Identified Issues: Tara April Special Exception Permit

**Affected Party
January 13, 2026**

KARST
ENVIRONMENTAL
SERVICES, INC.

Figure 1. Illustration of the Tara April, Tara Phoenicia, and Tara Forest West Projects

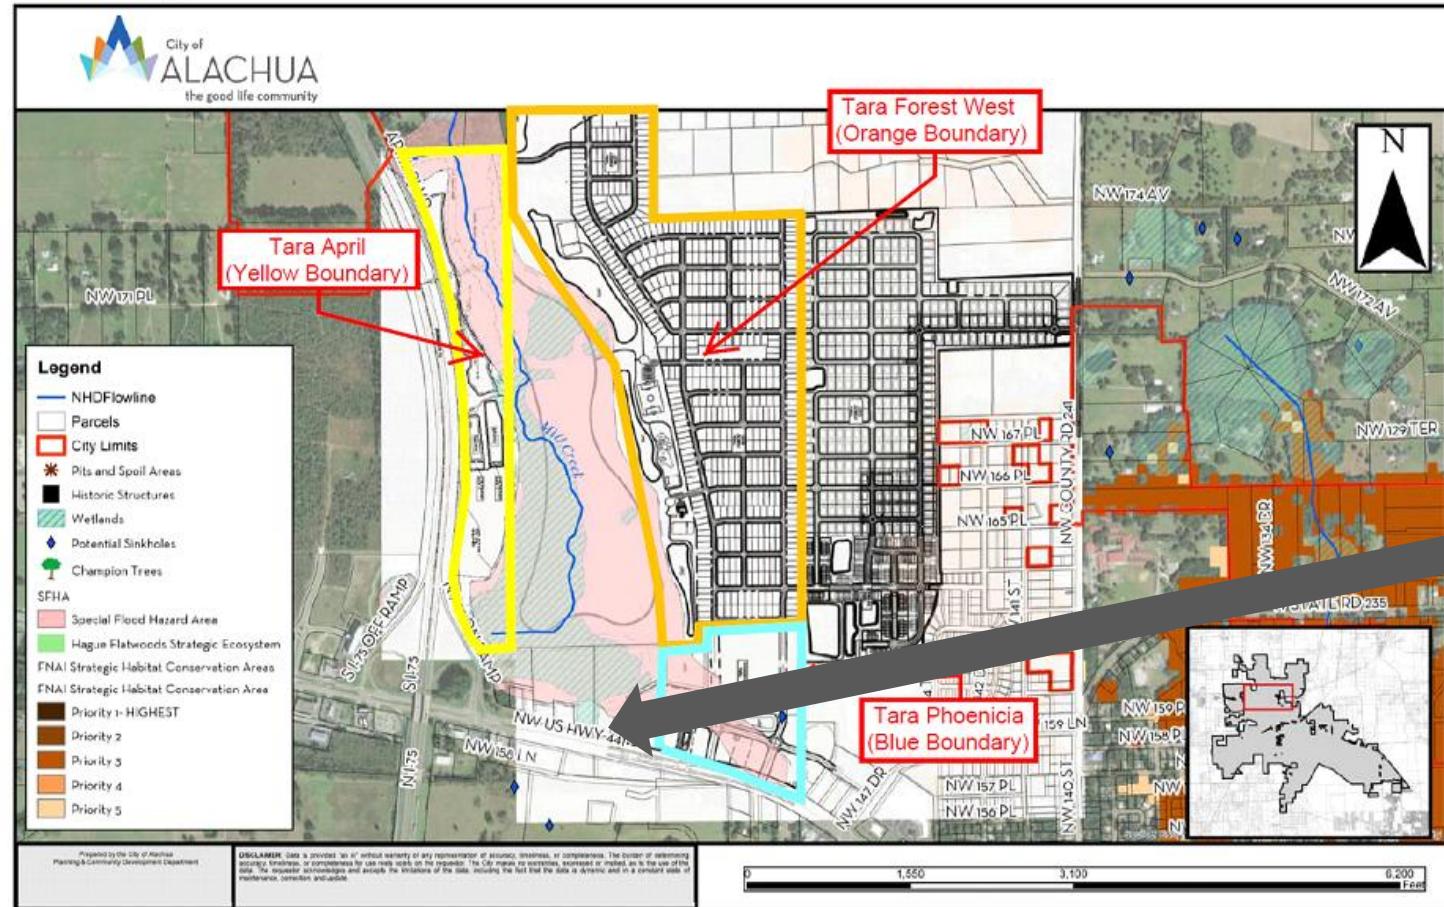
Mill Creek Sink

Report: Tara April within Sensitive Karst Area

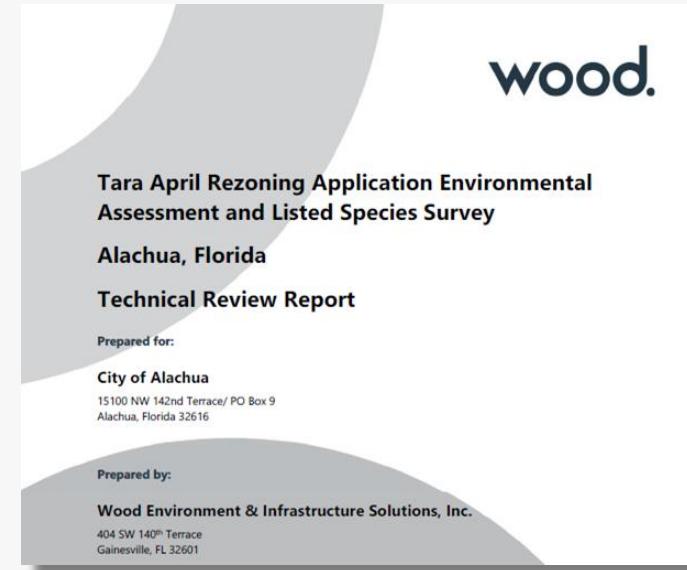
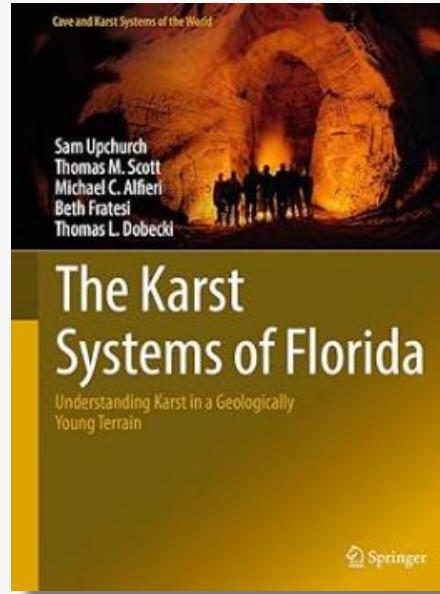
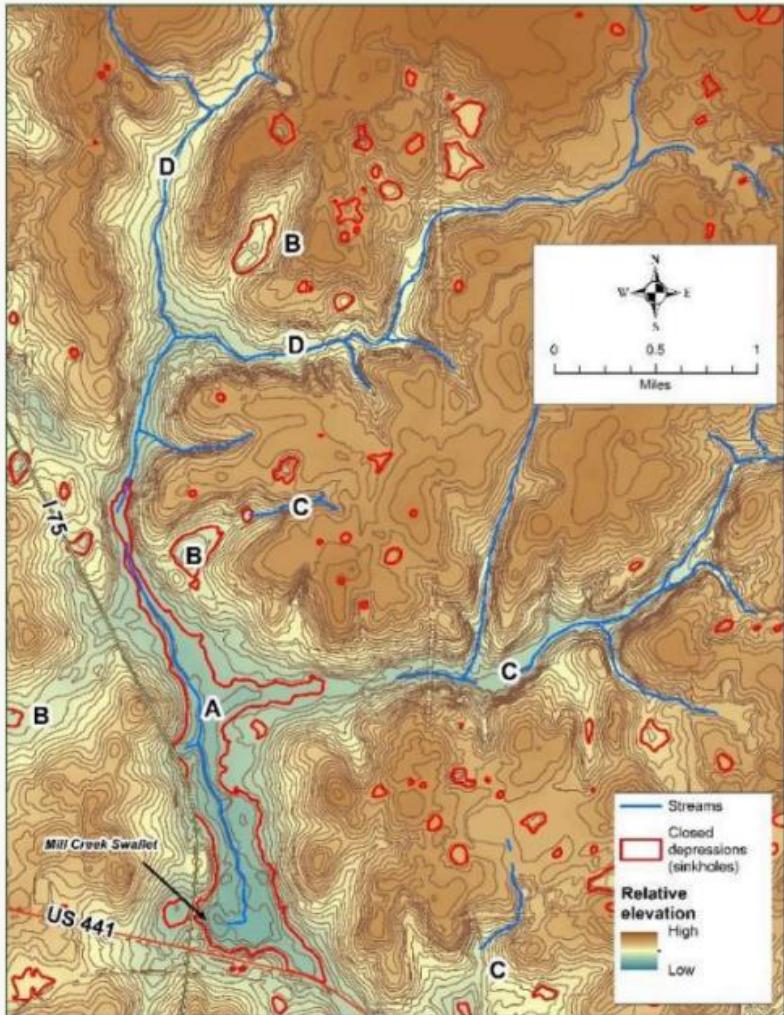
“...the site is within the Sensitive Karst Area of Alachua County where the Floridan Aquifer is at or near the land surface...”

The proposed stormwater facility is proposed near area with known Karst activity and formations.

Stormwater detention and treatment facility in this location can lead a accelerated formation of ground loss and sinkholes in the area due to the concentrating of acidic rainwater.

Application PSE22-0002 will have a negative effect on the adjacent uses both directly and indirectly and does not meet the definition of compatibility outlined in Fla. Stat. § 163.3164(9) *Compatibility* or in Section 2.4.4(D)(2) *Compatibility* of the City's Land Development Code.

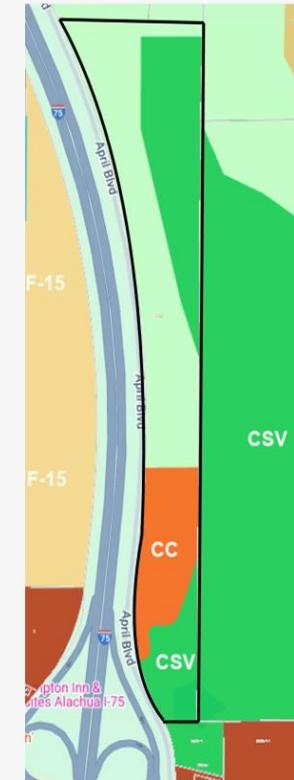
This proposed project is adjacent to Interstate 75 and April Boulevard.

A sinkhole will compromise the structural integrity of the interstate and cause injury to FDOT land and FDOT Right of Way (April Boulevard).

Application **PSE22-0002 does not meet Section 2.4.4(D)(5)**
Roads and other public facilities.

Application **PSE22-002 does not meet Section 2.4.4(D)(6)**
Not Injure Neighboring Land or Property Values.
